SR 520 'Rest of the West'

Meeting Summary

June 2, 2016

Figure 3: Examples of programming on proposed Montlake Lid

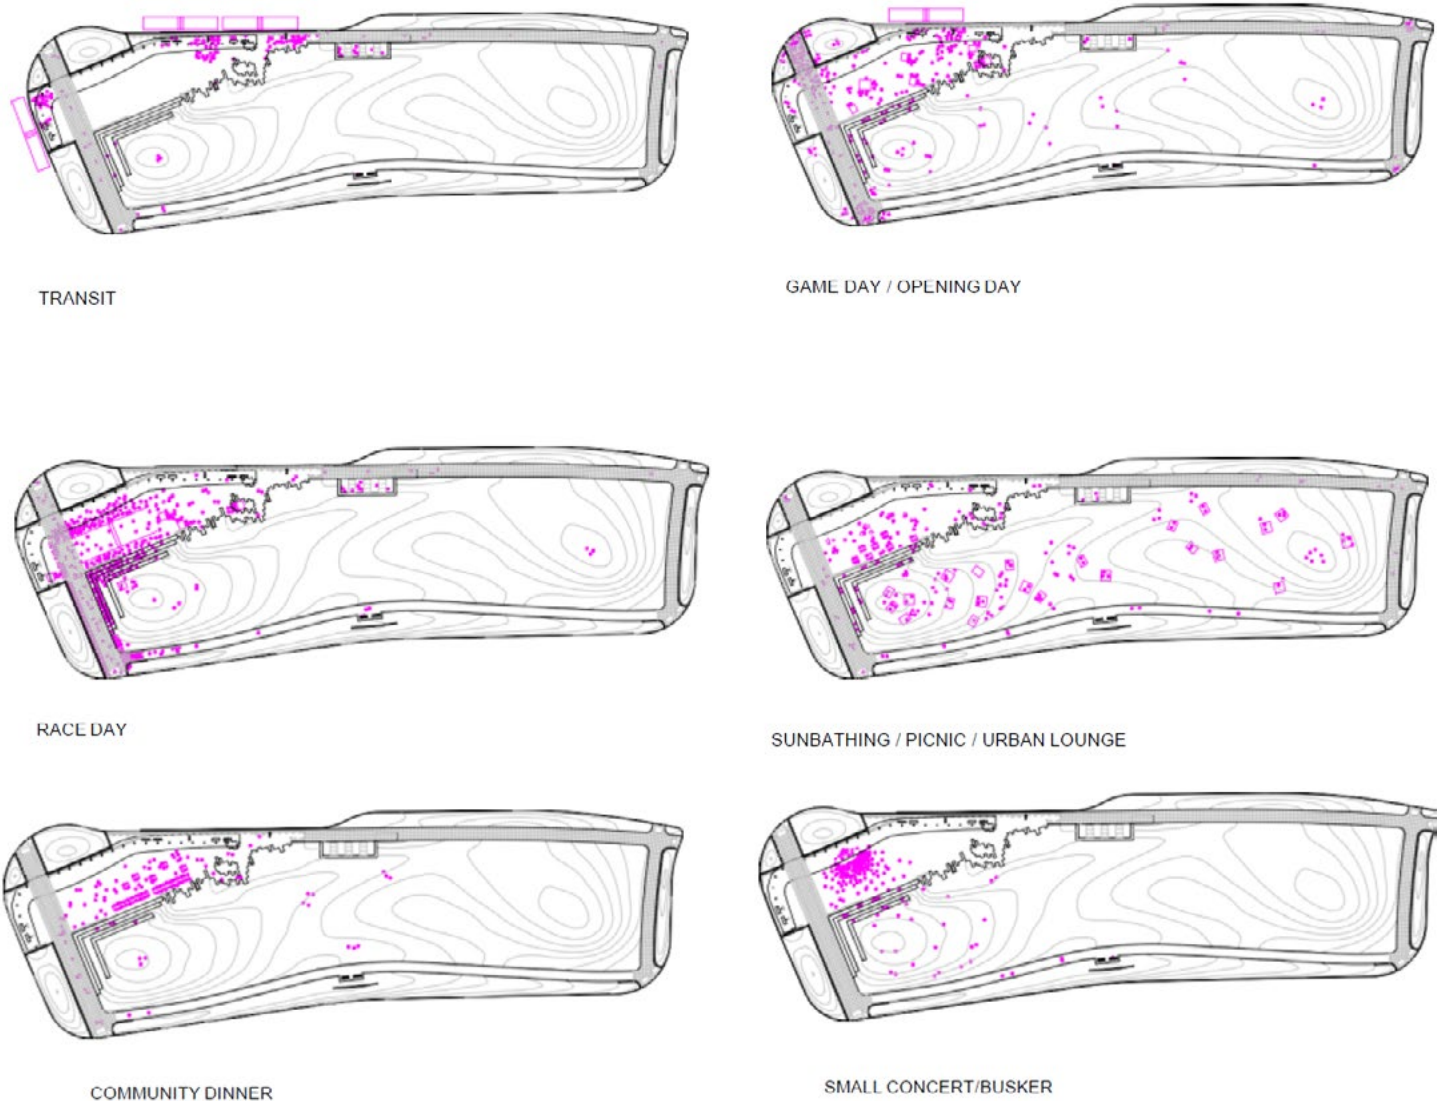
The Commission appreciated the location and design of nodes throughout the corridor, including mixing zones at either end of the landbridge, the plaza and transit mixing areas at the NW corner of the Lid, etc. Commissioners agreed nodes like this would allow users to have a unique experience. The SDC also appreciated the design team relocating the southbound Metro stop south of the proposed Lid along Montlake Boulevard as well as relocating the regional pathway to the north of the open space. The commission was concerned that the relocated transit stop south of the lid be better connected through pedestrian improvements or other wayfinding connections to the lid and its transit connections.
